6140 SOUTHMOOR DRIVE

SITE DEVELOPMENT PLAN

THE PURPOSE OF THIS SITE DEVELOPMENT PLAN AMENDMENT IS TO CONSTRUCT A METAL BUILDING AND PAVED PARKING.

COVER SHEET
SITE DEVELOPMENT PLAN
6140 SOUTHMOOR DRIVE
FOUNTAIN, COLORADO

SITE PLAN

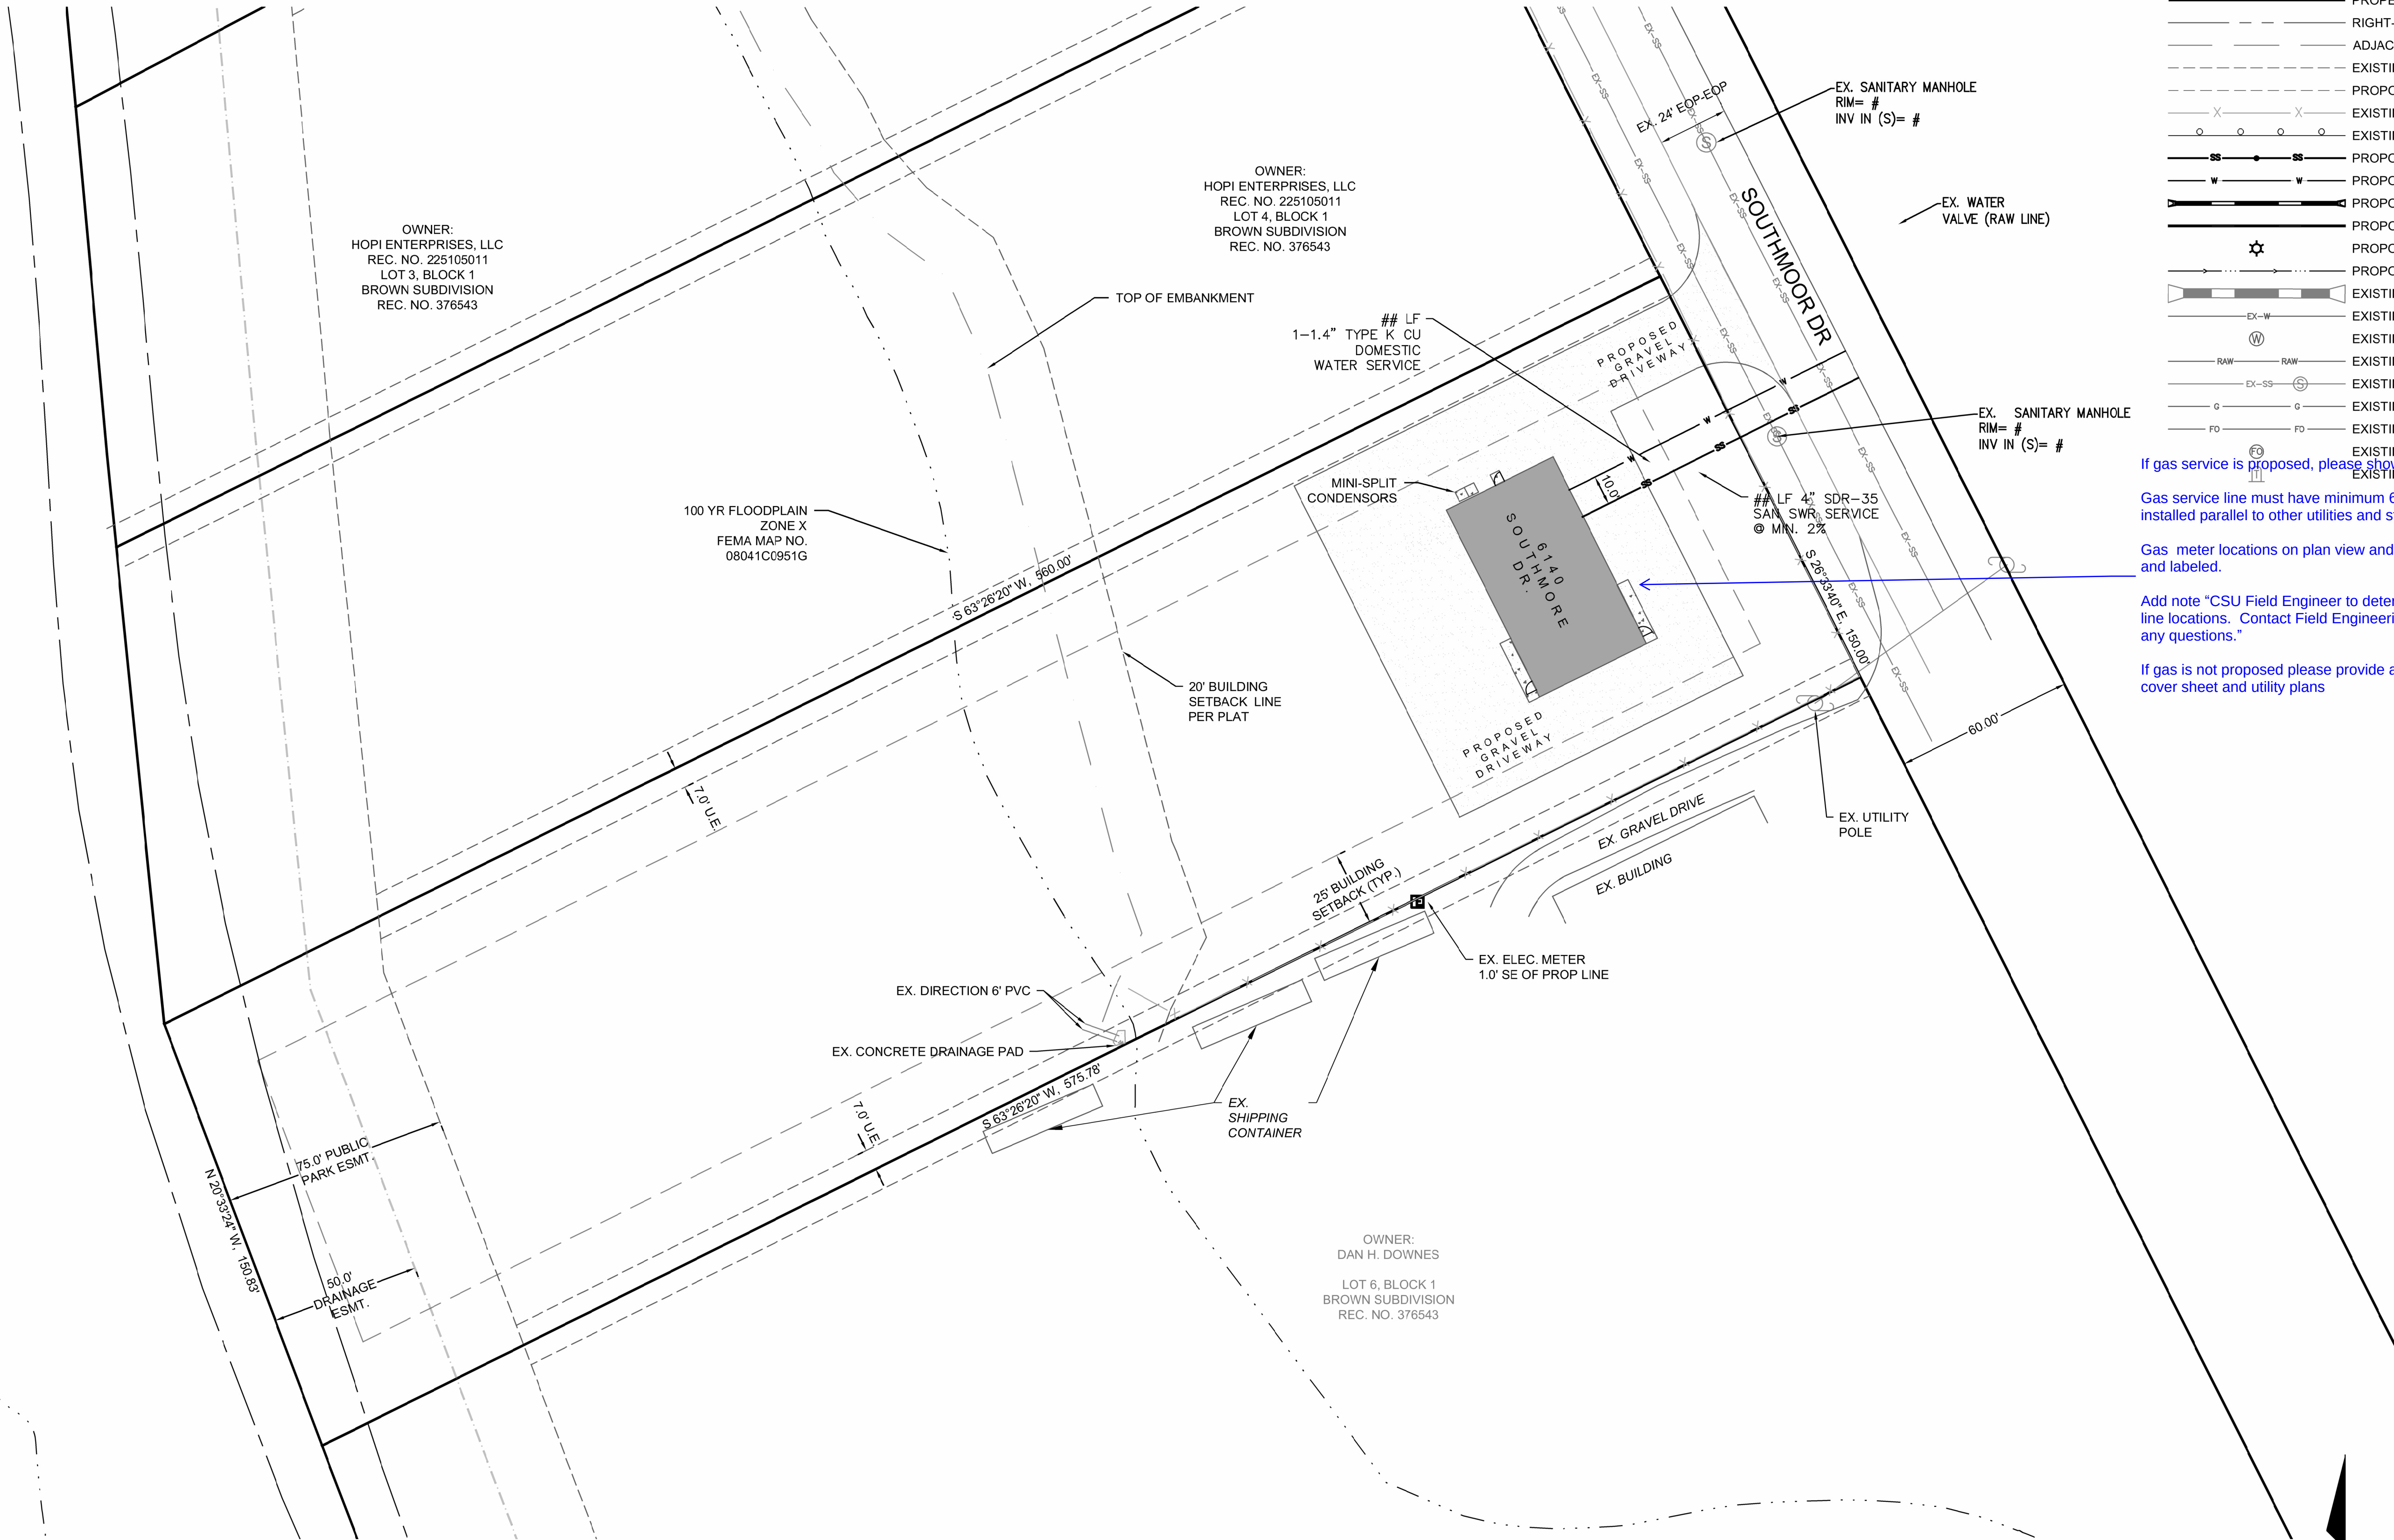
Show and label
existing Gas
Distribution Main:
N45M112 on all
applicable sheets

Please confirm if
natural gas service is
being proposed as it
was not indicated in
the letter of intent

UTILITY PLAN

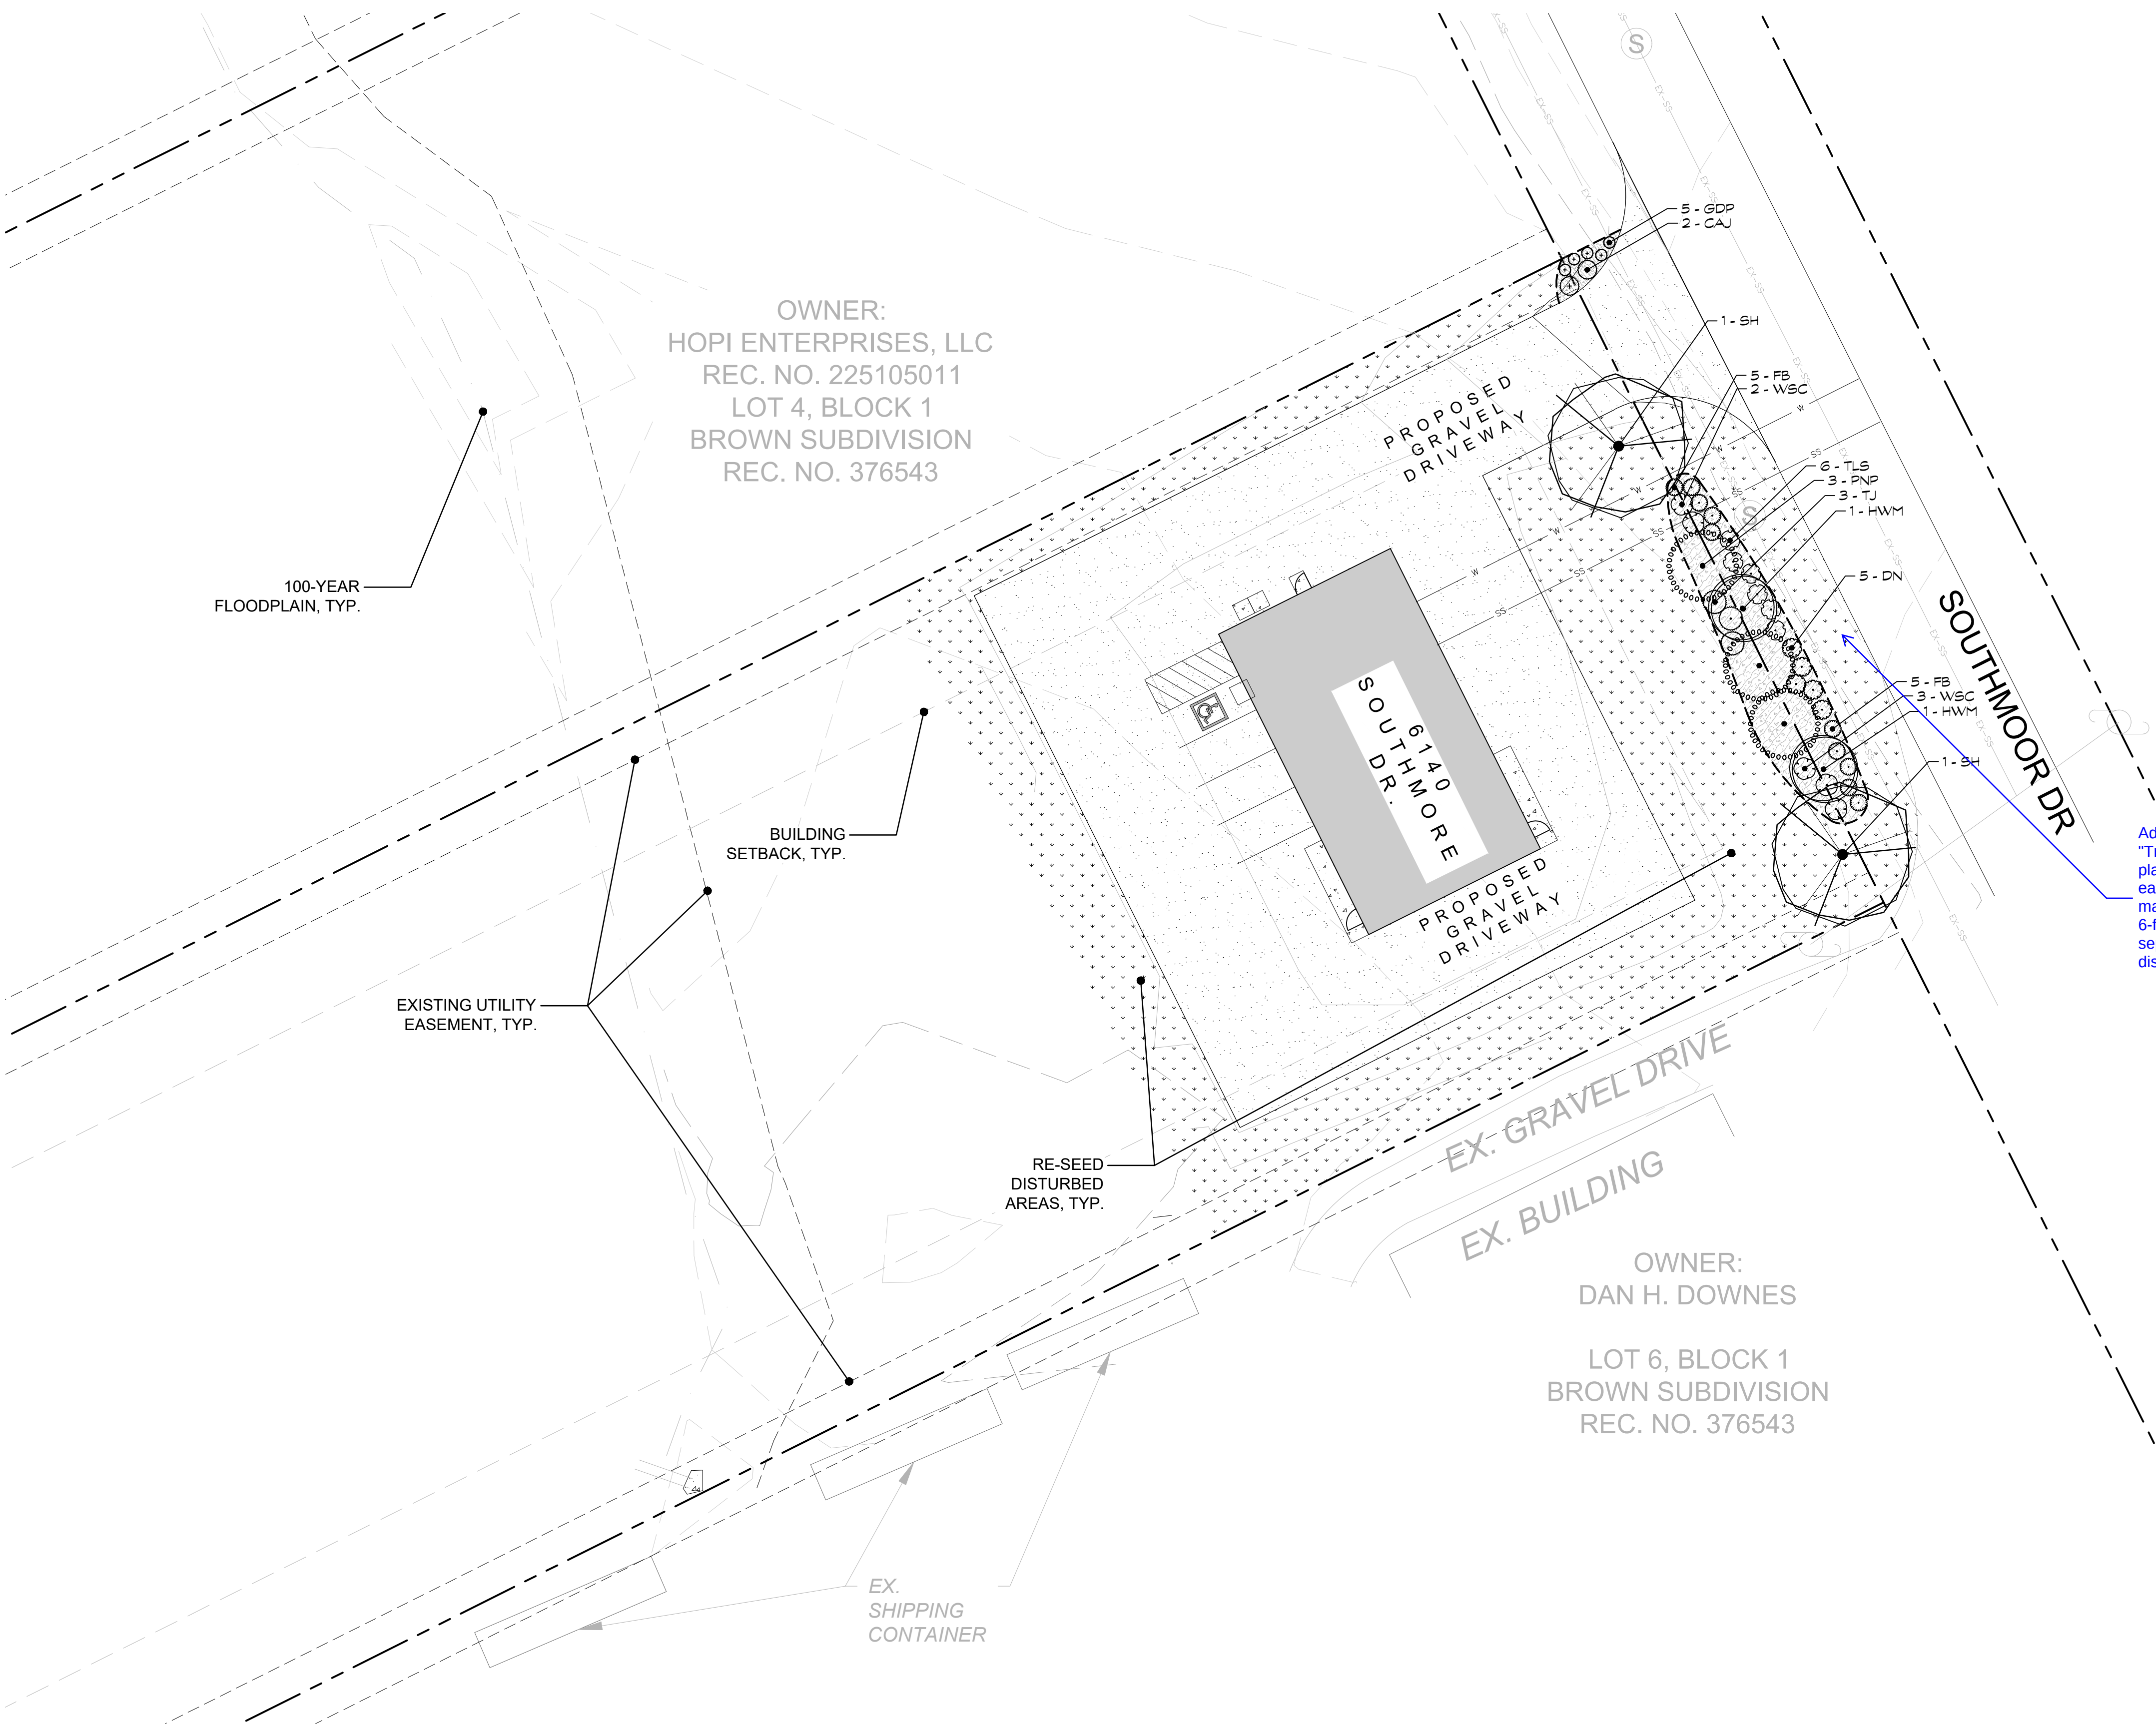
If gas service is proposed, please show, label, confirm the following:
Gas service line must have minimum 6-foot horizontal separation when installed parallel to other utilities and structures.
Gas meter locations on plan view and building elevations must be shown and labeled.
Add note "CSU Field Engineer to determine final gas meter, and service line locations. Contact Field Engineering at 719-668-4985 (Gas) with any questions."
If gas is not proposed please provide a note that indicates as such on the cover sheet and utility plans
